MODIFICATION

REPLACEMENT OF

DC GENERATOR CIRCUIT BREAKERS

(This EO replaces EO 05-45B-6A/240 dated 7 Aug 68)

Figure 1 (Issue 2)

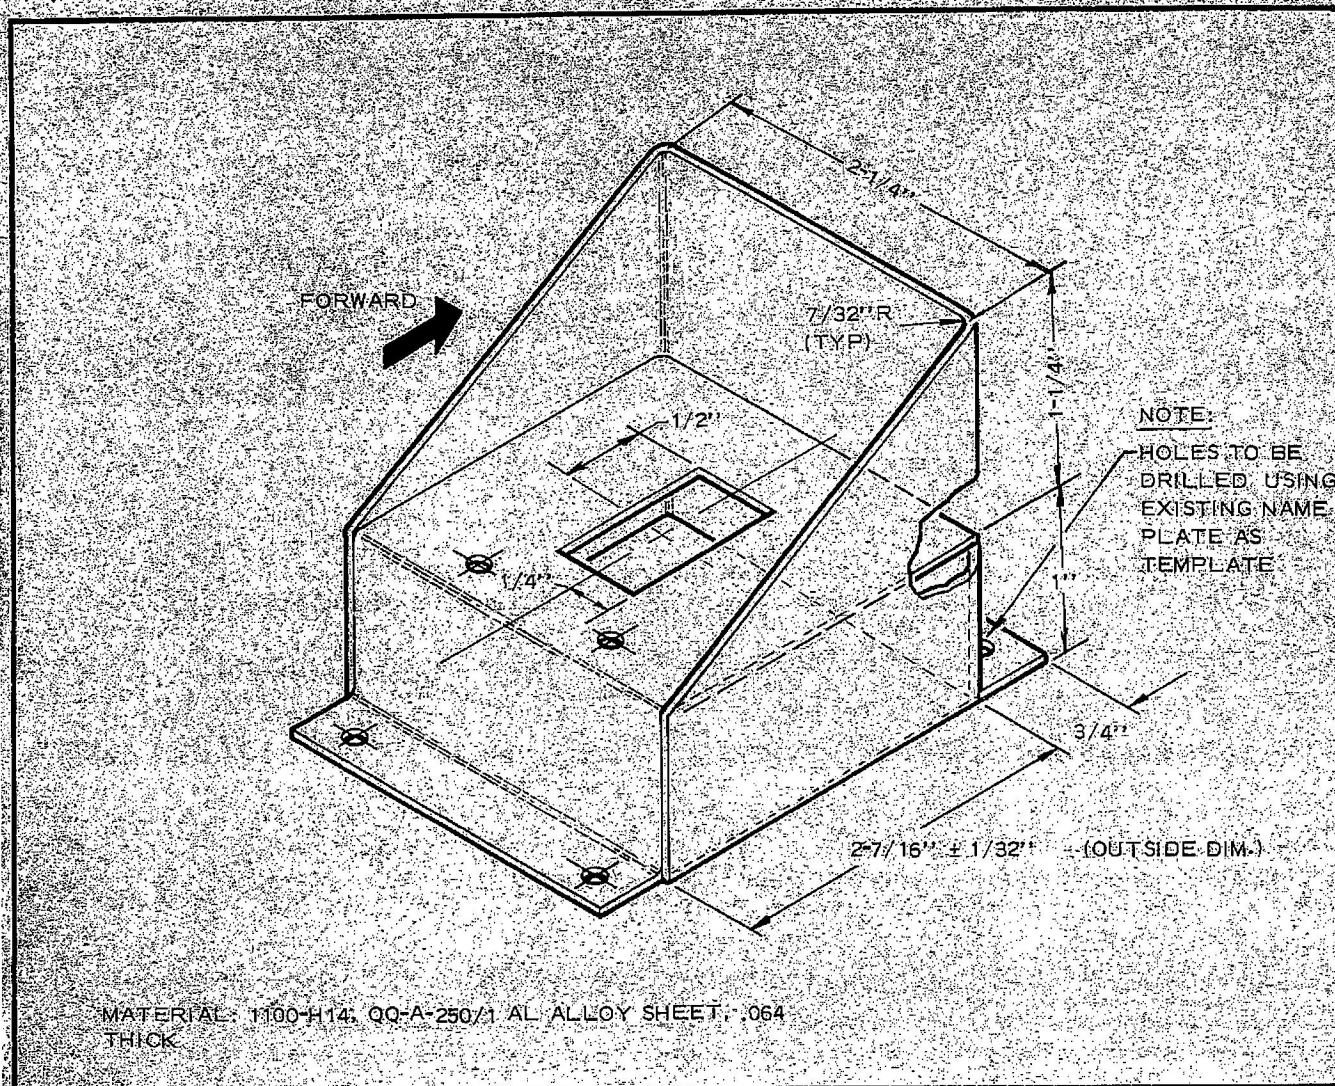
- (a) Disconnect aircraft batteries and external power source.
- (b) Remove belly panel to gain access to DC generator circuit breakers.
- (c) Disconnect hose assembly Part 109644-022-5A from cockpit air valve assembly Part 404-183948 left-hand and Part 404-183948-1 right-hand.
- (d) Disconnect and remove left and right-hand circuit breakers Ref. 5925-00-109-1762.
- (e) Rework holes in cockpit floor to accommodate toggle type circuit breakers Ref. 5925-00-144-0482.
- (f) Locally manufacture each two brackets as per Figure 1 using sheet aluminum 2S 1/2 H thickness .064 Ref. 9535-21-813-8542.

Figure 2

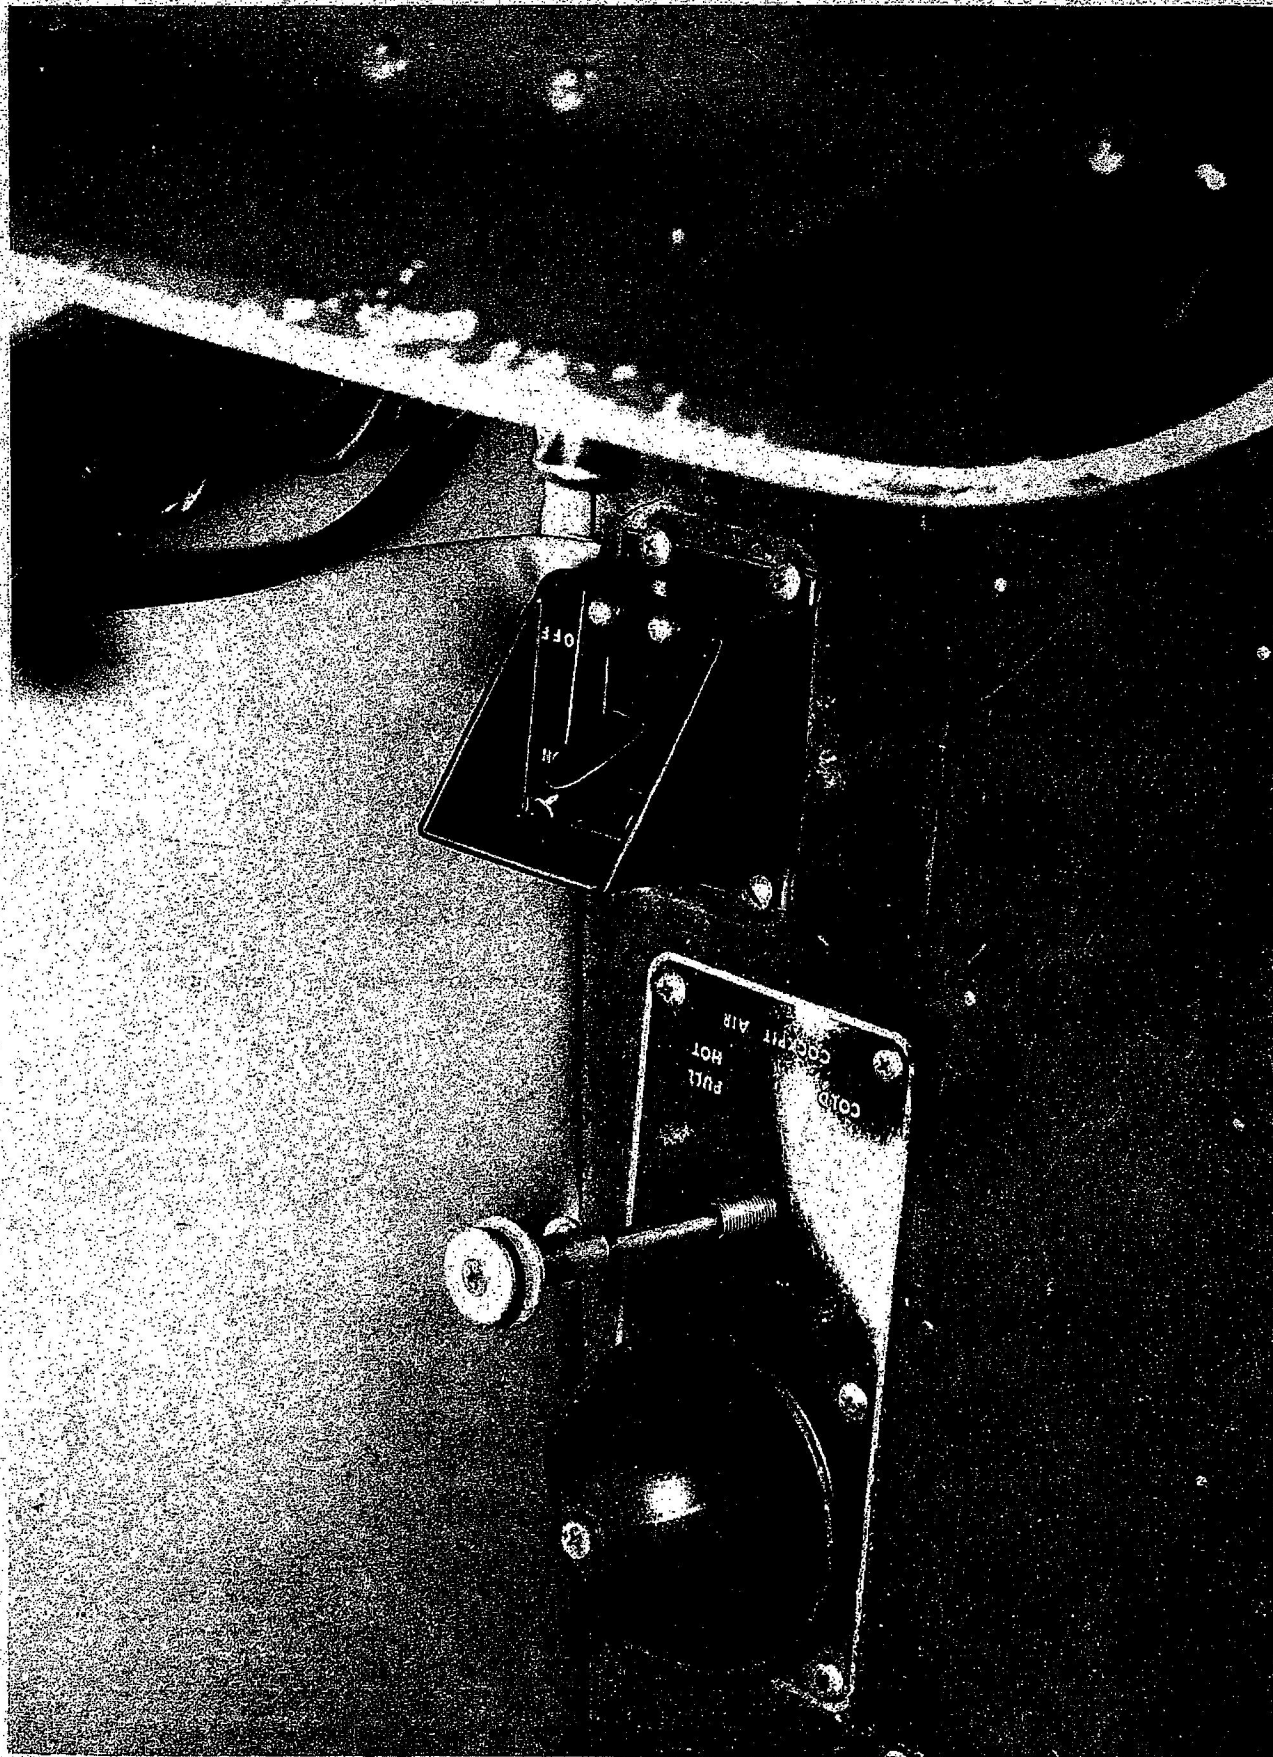
- (g) Install new circuit breakers Ref. 5925-00-144-0482 in brackets and fit assembly to cockpit floor as per Figure 2.
- (h) Reconnect generator circuit to new circuit breakers.
- (i) Reconnect hose assemblies Part 109644-022-5A to cockpit air valve assembly.
- (k) Replace belly panel.
- (m) Reconnect aircraft batteries.
- (n) Ground run aircraft to check generator circuit.
